The Cambridge South East Transport Order

The Applicant's Request for Changes to the Application

Document Reference	CD-CR0
Revision Number	00
Applicant	Cambridgeshire County Council
Date	October 2026

Figure 1

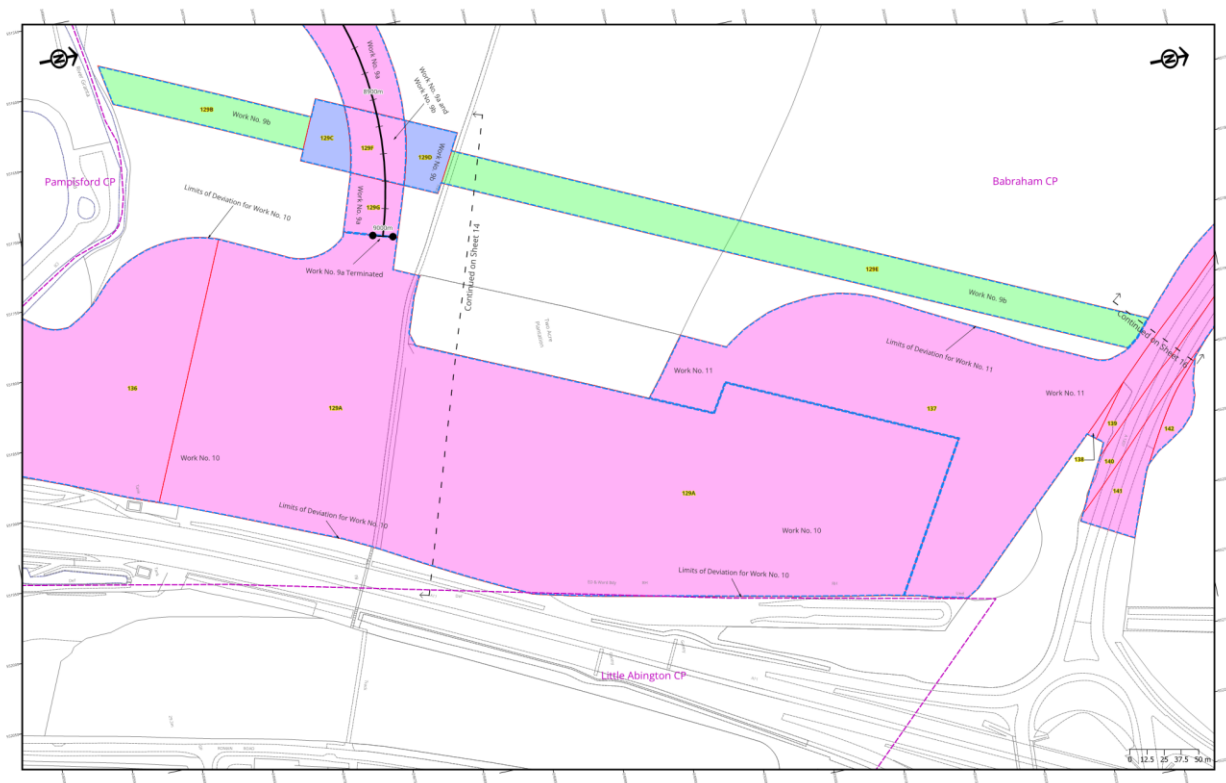
- 3.1 Change Request 1 includes the changes required to mitigate the impact of the Scheme on the Pipeline. Written confirmation that NGT agrees with these changes and the proposed mitigation is appended to this document at Annex 1.
- 3.2 Change Request 1 seeks to increase the Order limits where the busway crosses the Pipeline and runs alongside the travel hub. Figure 2 identifies the additional area of land to be included within the Order limits in order to effect this change.

- 3.4 An extension of the Order limits is required in order to enable a minor diversion of the Pipeline (circa. 107 metres in length) and the installation of protective measures (a protective mesh) for the length of Pipeline which runs alongside the Travel Hub. The Applicant seeks temporary rights to construct the diversion and install protective measures over the Pipeline as well as permanent rights to retain in situ and maintain the diverted length of the Pipeline. Existing rights over the Pipeline enable the protective measures to be retained in situ and maintained, so no permanent rights are required for the works relating to the protective measures. The amended Works and Land Plans [**CD-CR7**] depict the additional land required and the rights the Applicant proposes to take over this land.

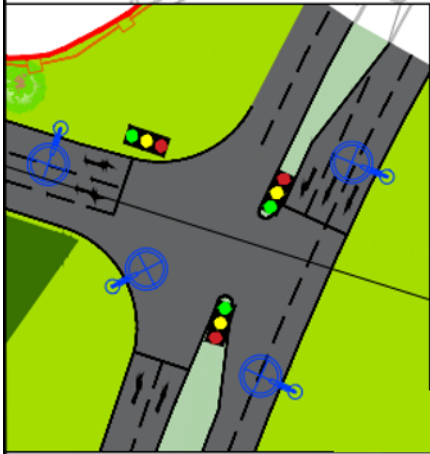
- 3.6 Change Request 1 also proposes amendments to the layout of the Travel Hub and the access arrangements to the Travel Hub on the A1307 Cambridge Road. No change to the Order limits is required to facilitate these amendments, which are design changes only. The layout of the Travel

Drawing Title							
TRAVEL HUB (NGT RED LINE BOUNDARY)							
Drawing Number							
Project							
51212868 - ATK - HGN -							
WHL_AL - SK - CH - 000042							
Location							
Type							
Number							
Original Size: A1							
Scale: NTS							
Project Ref. No: 51212868

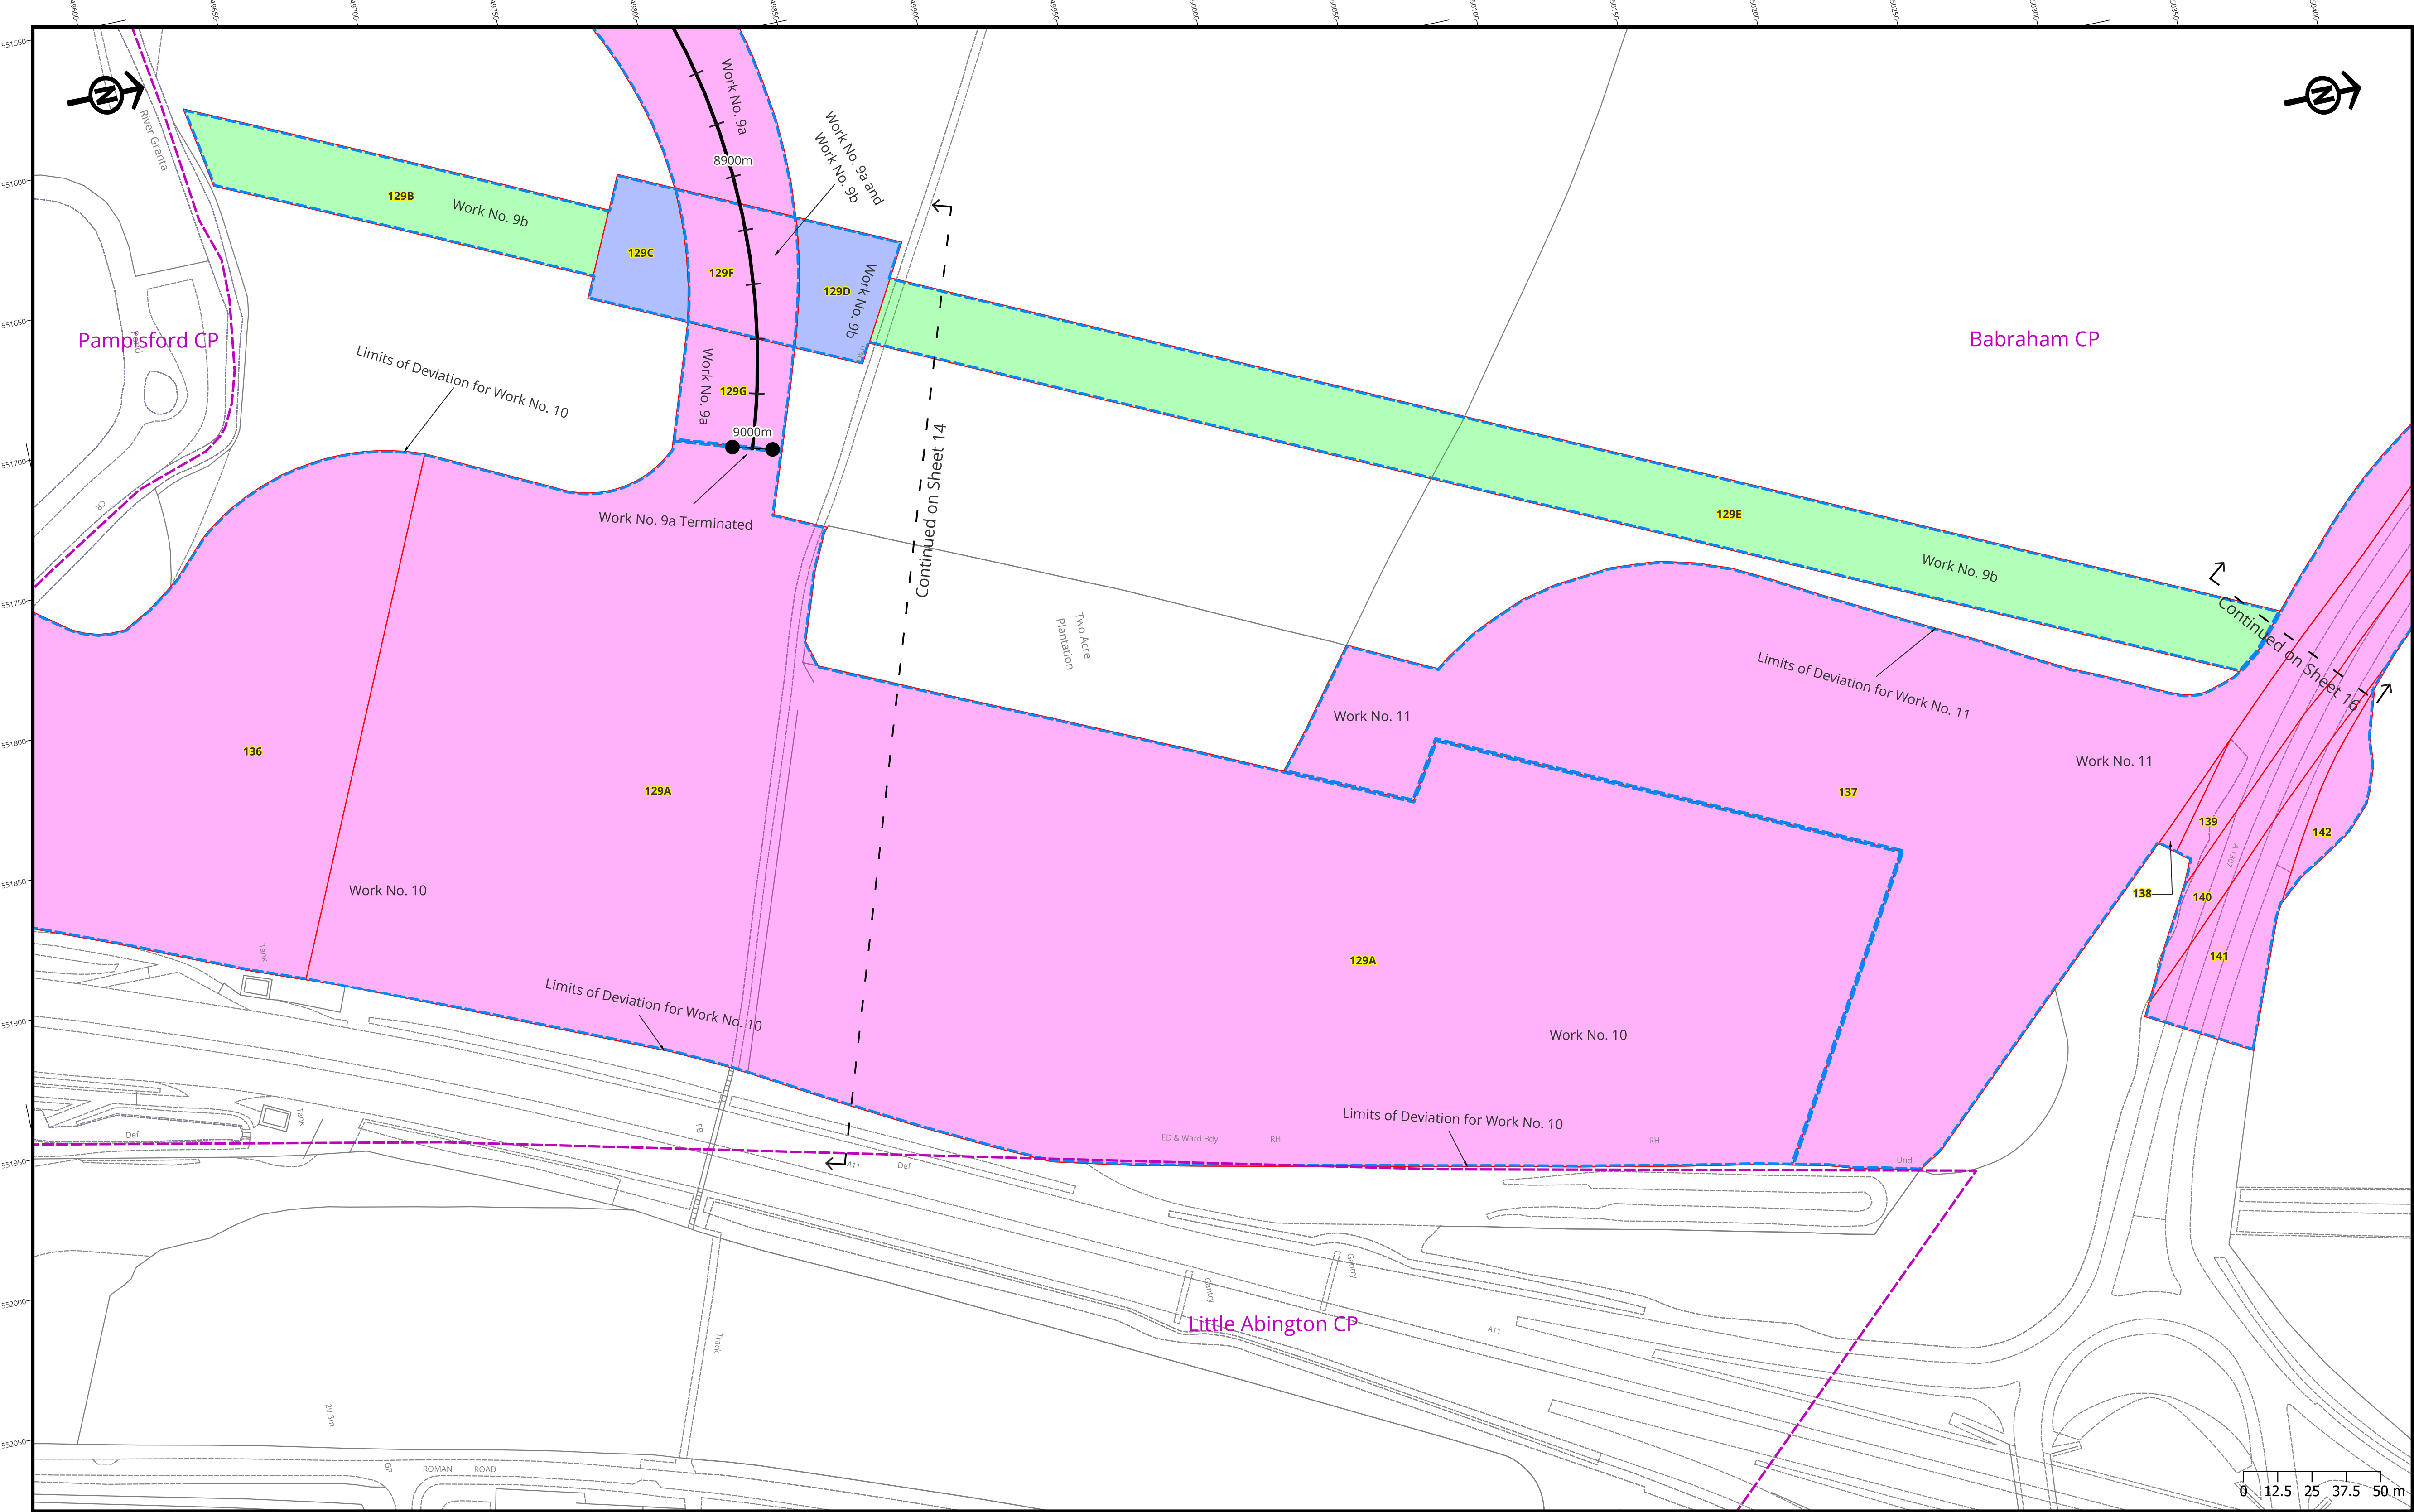
As you are aware, the Council have been engaging with National Gas Transmission in relation to the diversion of a short section of the FM03 – Gt Wilbraham to Whitwell gas pipeline to facilitate delivery of the Scheme. The pipeline diversion is required where the proposed busway crosses the existing pipeline on land within your ownership. The Council intends to submit a request to extend the Order limits in this location to enable the pipeline diversion to be undertaken as part of the Scheme. The change proposed and the land affected is depicted on the enclosed plan. As part of the request to make this change, the Council will also seek deemed planning permission to construct and operate the diverted pipeline as well as compulsory powers to acquire the rights and temporary land to facilitate this, in the event that either a voluntary agreement cannot be negotiated or compulsory powers are necessary to deal with third party land interests.

We consent to Cambridgeshire County Council's request to extend the Order limits to permit the grant of deemed planning permission for the construction and operation of a diversion to the FM03 – Gt Wilbraham to Whitwell pipeline (Pipeline Diversion) and to the inclusion in the Order of provisions authorising compulsory acquisition of the additional land affected by the Pipeline Diversion, which additional land is shown on the enclosed plan.
